Cobb County Community Development Agency
Zoning Division

Case # Z-75

FINAL ZONING STAFF RECOMMENDATION:

Rezoning Plat for

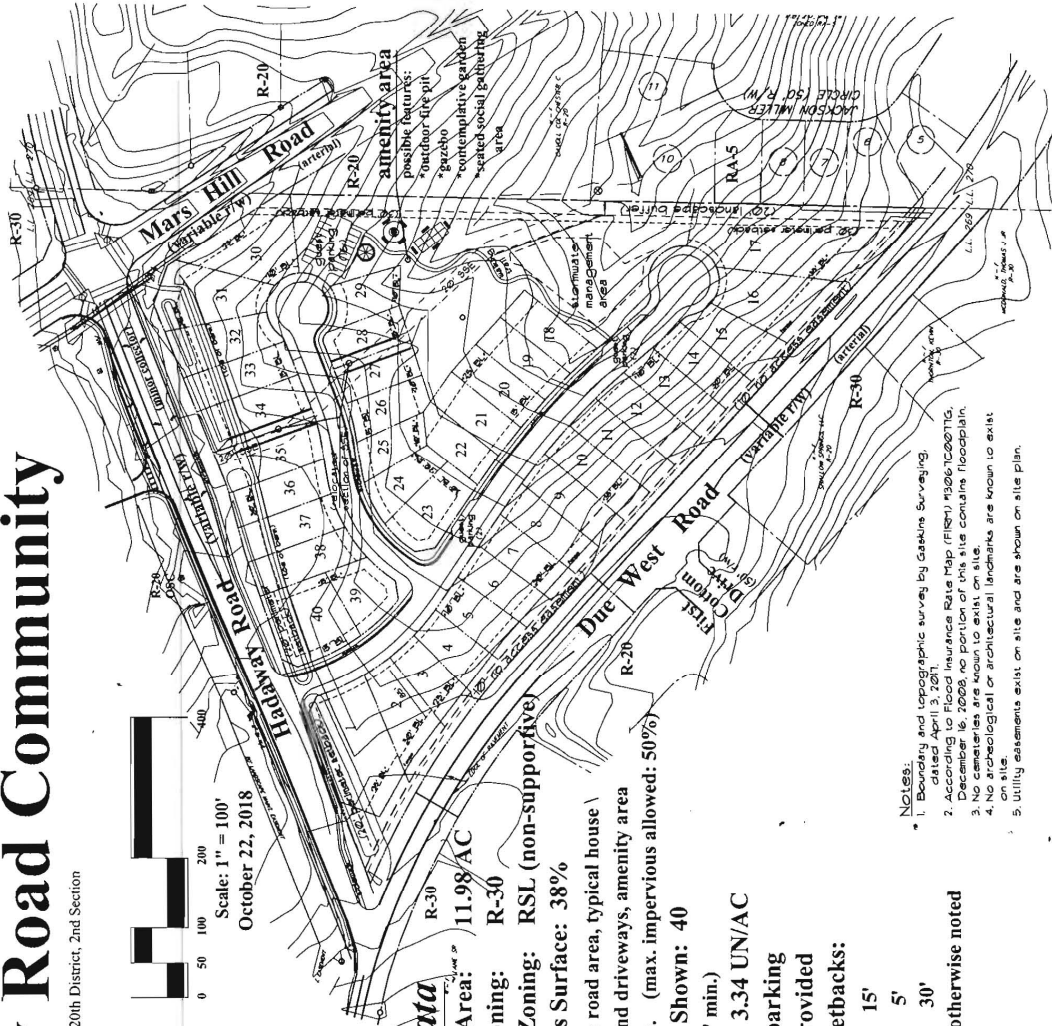
1. Reduce the distance between homes from 15 feet to 10 feet; and
2. Reduce the landscaped buffer abutting more restrictive residential zoning from the required 20 feet to 10 feet (along the eastern property line).

- Side setback will need to be a minimum of 5 ft. each side providing a 10-foot-wide (clear to sky) space between building roof lines.

1. Flood hazard: No
2. Flood hazard zone: Zone X
3. Drainage Basin: Allatoona Creek
4. Wetlands: Yes Location: identified on site plan
5. The Owner/Developer is responsible for obtaining any required wetland permits from the U.S. Army Corps of Engineers.

11. Minimize the effect of concentrated stormwater discharges onto adjacent properties.
12. Project engineer must evaluate the impact of increased volume of runoff generated by the proposed project on existing downstream receiving system. A storage routing will be required for the existing detention pond within the West Hill Crossing Subdivision located immediately downstream.

13. Special site conditions and/or additional comments:
 - The entire site drains to the southeast into and through the West Hill Crossing Subdivision. Existing offsite runoff from the north side of Hadaway Road must be properly conveyed through the site.

4. Recommend curb, gutter, and sidewalk along the frontage of Hadaway Road, Mars Hill Road, and Due West Road.
5. Recommend curb and gutter along both sides and sidewalk along one side of proposed development roadway.
6. Recommend the driveways for lots 1 and 40 be a minimum tangent distance of 50 ft from Hadaway Road.
7. Recommend a 10' no access easement for the lots that border Hadaway Road, Mars Hill Road, and Due West Road.
8. Recommend a minimum driveway length of 20 ft between the right-of-way and garage.
9. Recommend private streets be constructed to the Cobb County Standard Specifications and be clearly labelled as private on the site plan.
